Staff Review 2nd Transmittal

Weber County Planning Division

Application Request: Shanghai Canyon Subdivision, a one lot subdivision
Applicant: David Clapier
File Number: UVS 081414

Shanghai Canyon Subdivision

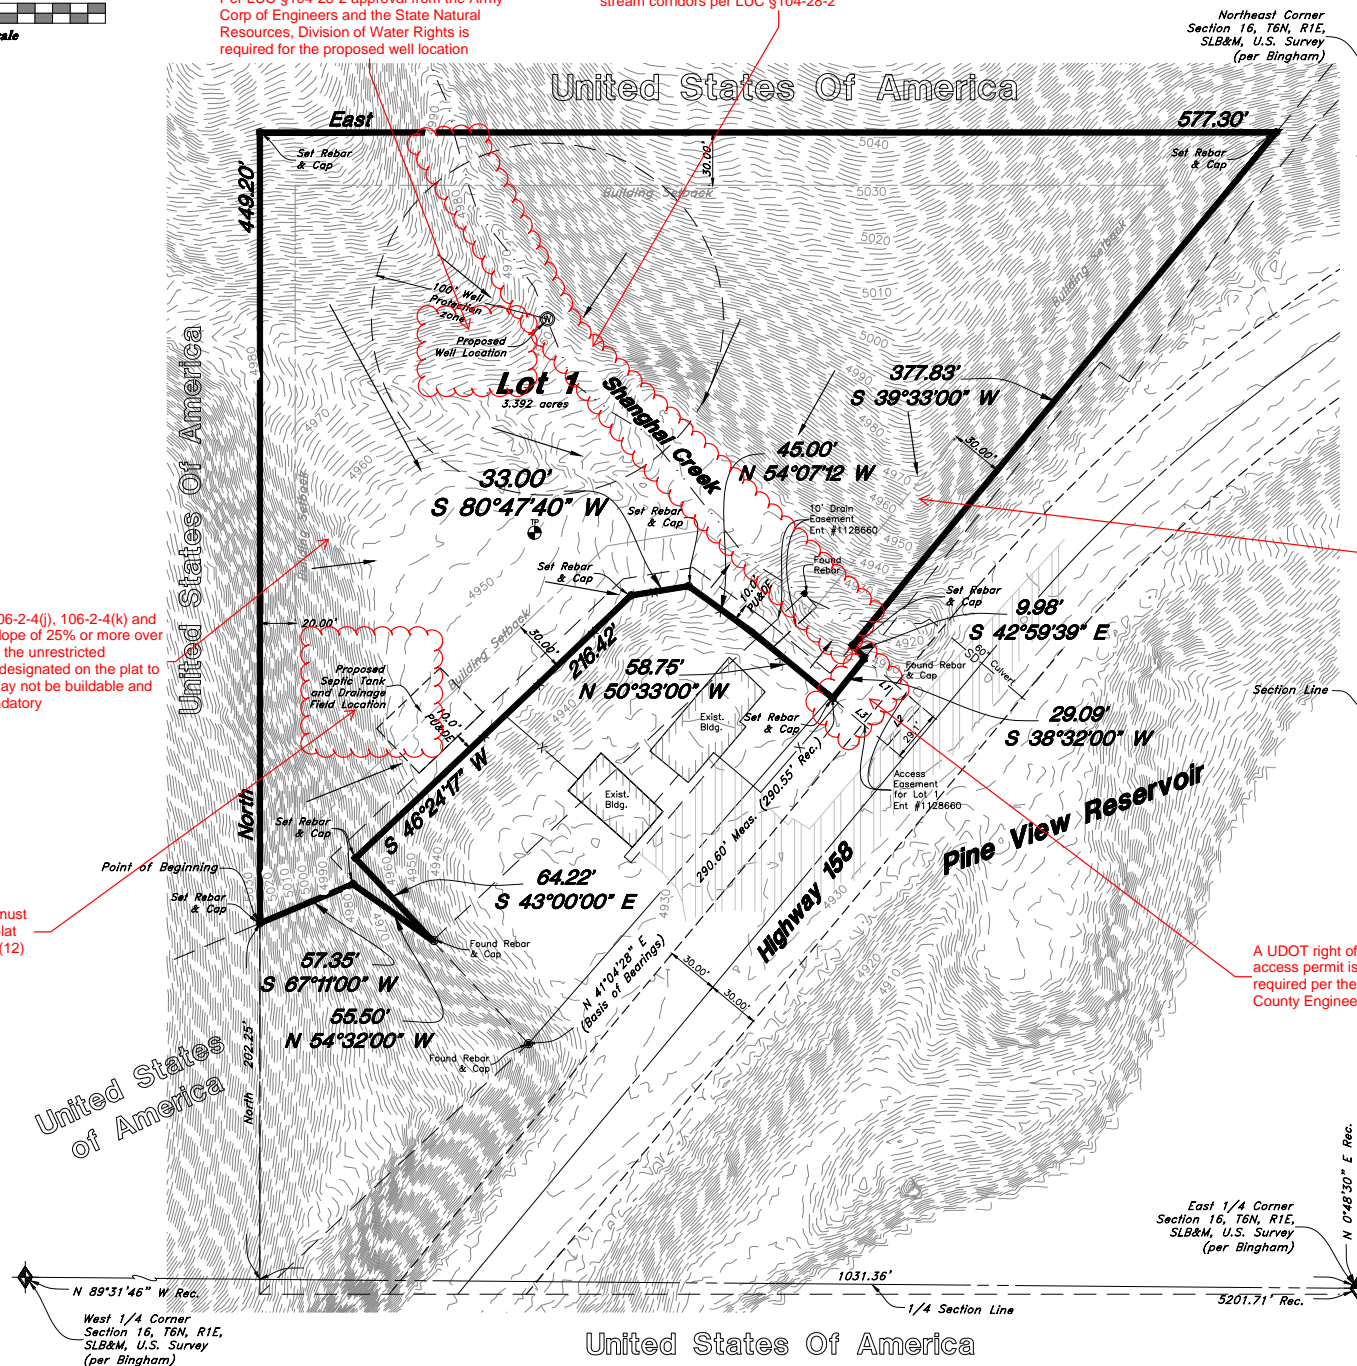
The legal description in the title report needs match the boundary description on the plat map.

Per LUC §106-1-8(f) a house number indicating the street address for each lot in the subdivision shall be marked on each lot

The title report does not identify Ogden River Water Users Association as a vested owner. Please have the title report updated to include Ogden River Association as an owner or remove from the plat map

The title report has identified multiple owners on title. Please provide signature lines for the individual owners as vested to sign the plat map

The title report has identified multiple owners on title. Please provide adequate acknowledgements for the individual owners as vested

Per LUC §104-28-2 approval from the Army Corp of Engineers and the State Natural Resources, Division of Water Rights is required for the proposed well location

A 50' setback/no build line from the high water mark needs to be identified on the plat for all intermittent stream corridors per LUC §104-28-2

Per LUC §106-1-5(11) & LUC §106-2-4(j), 106-2-4(k) and 106-1-8(4) lots with an average slope of 25% or more over a portion of the area shall identify the unrestricted buildable area or an "R" must be designated on the plat to notify future owners that the lot may not be buildable and a "Hillside Review" would be mandatory

Test pit locations must be shown on the plat per LUC §106-1-5(12)

A UDOT right of way access permit is required per the County Engineer
